LIVING & LEARNING ENRICHMENT CENTER JSP 19-08

Public hearing at the request of Living & Learning Enrichment Center for Special Land Use, Preliminary Site Plan and Storm Water Management plan approval. The subject property contains 14.79 acres and is located in Section 35, on the south and west side of Eight Mile Road, north of Griswold. The site is known as the former Massey Estate. The applicant is proposing to repurpose the existing buildings and grounds for use by the non-profit organization, which serves teenagers and young adults with autism and related challenges.

PLAN REVIEW CENTER REPORT

Review Date: August 28, 2020
Review Type: Preliminary Site Plan
Project Name: JSP 19-08 LIVING & LEARNING ENRICHMENT CENTER
Location: 801 Griswold Street; 22-35-351-002
Plan Date: June 19, 2020
Prepared by: Lindsay Bell, AICP, Senior Planner
Contact: E-mail: lbell@cityofnovi.org; Phone: (248) 347-0484

SHEET 3

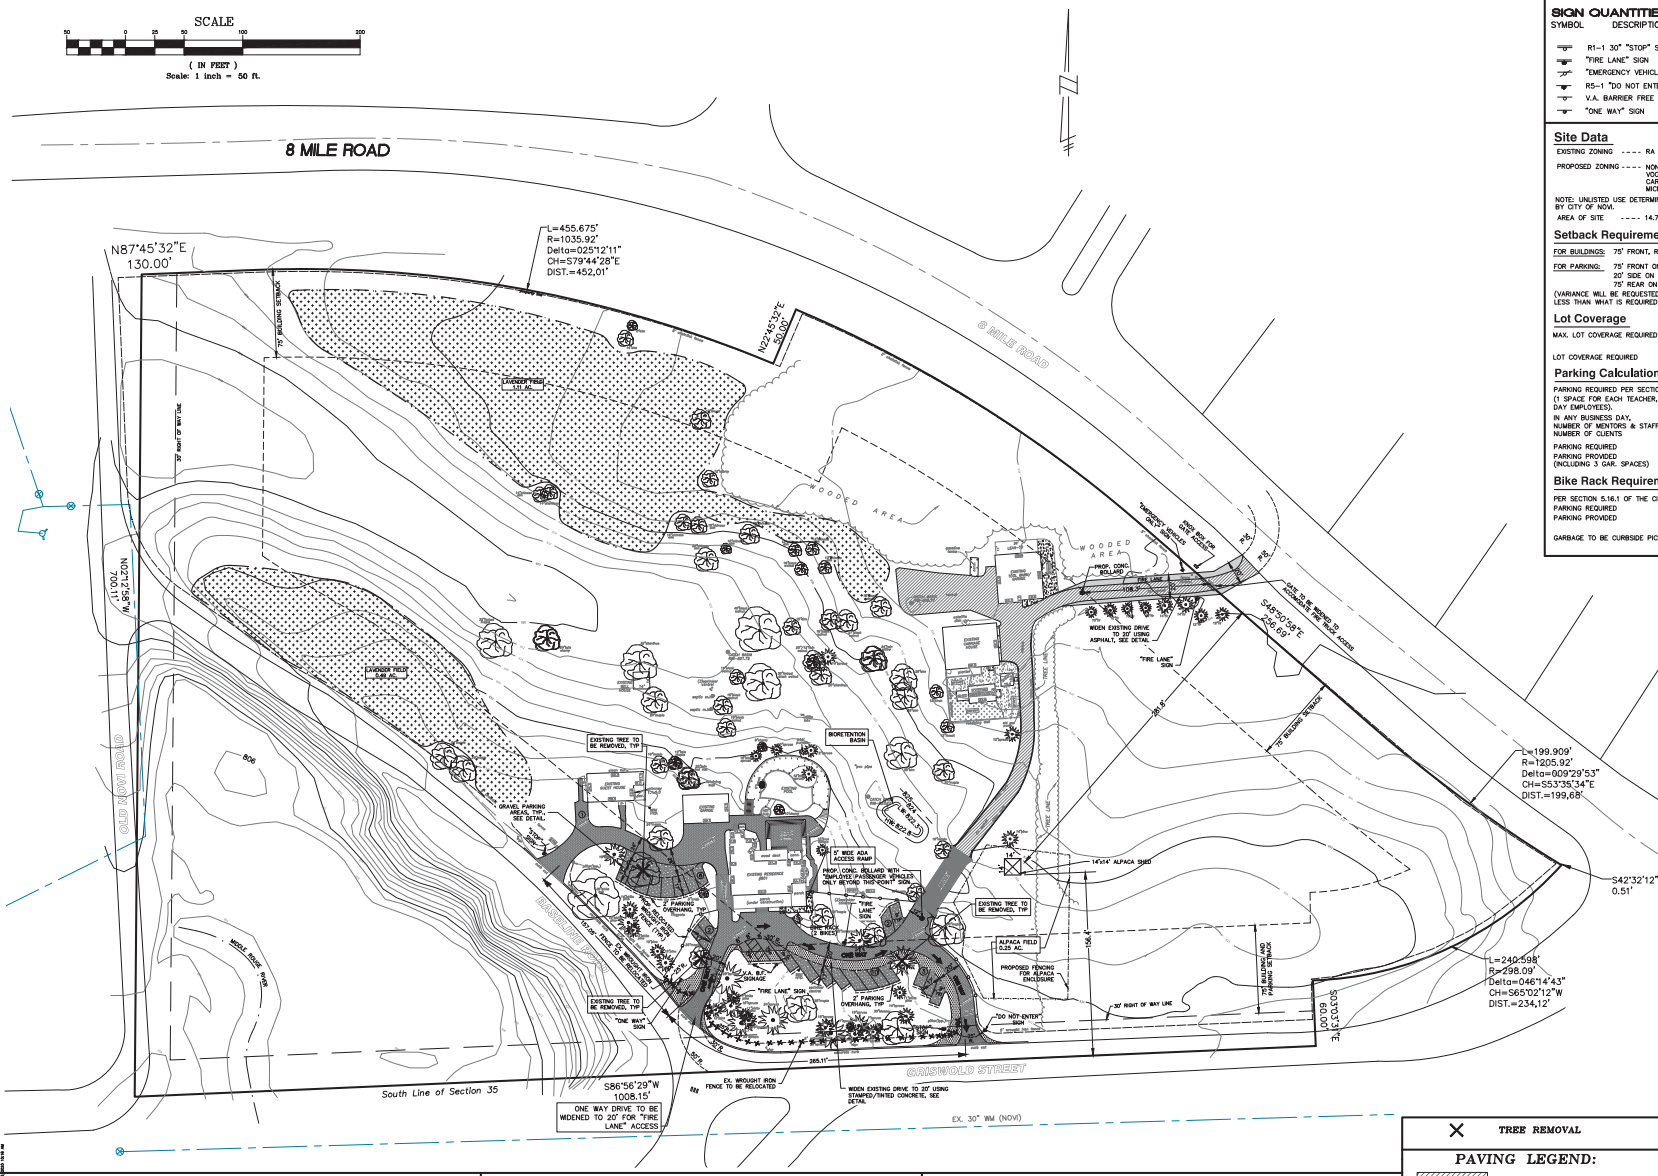
12. Remove the paving details on sheet 3 and reference the City of Novi Paving Detail Sheets.
13. The City's Non-Motorized Master Plan requires a sidewalk along the south side of Eight Mile Road and the north side of Griswold Street. If the intent is not to construct this sidewalk, then a **Design and Construction Standards Variance** must be requested. The Engineering Division does not object to this request since there is a lack of sidewalks within 300 feet of the requested sidewalks.

Preliminary Site Plan - Storm Water Management Plan

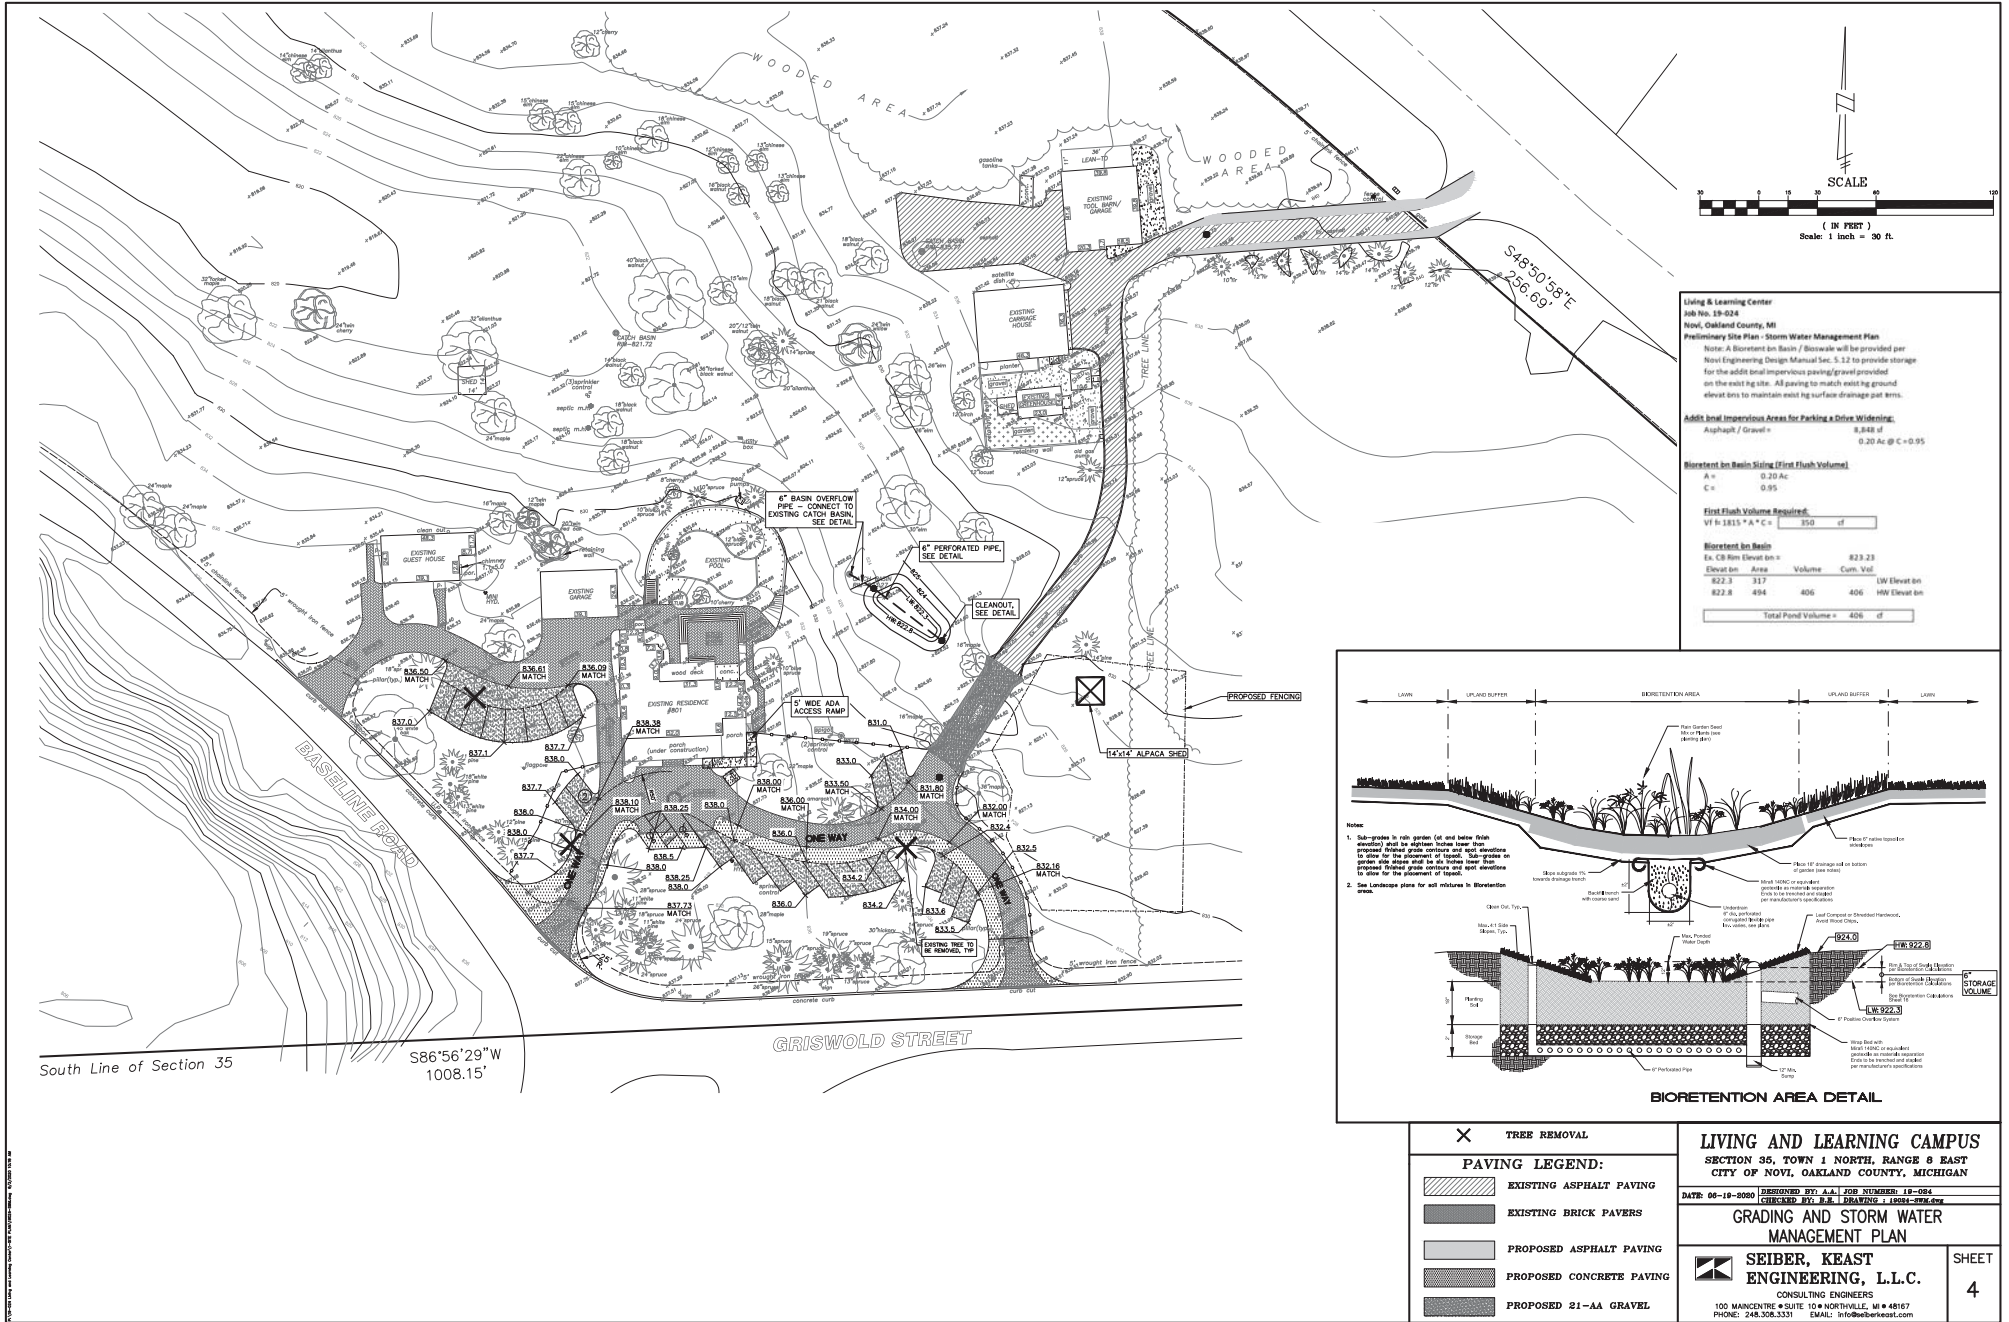
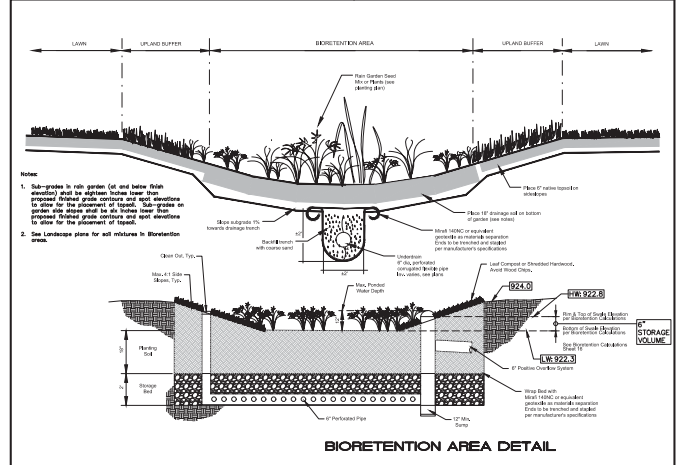
17. The impact of the proposed impervious surfaces on storm water management plan is considered negligible. Therefore, this development is not required to store the 100-year flood volume.
18. Label the existing catch basin being tied into on the bioretention profile and show the ultimate outlet.
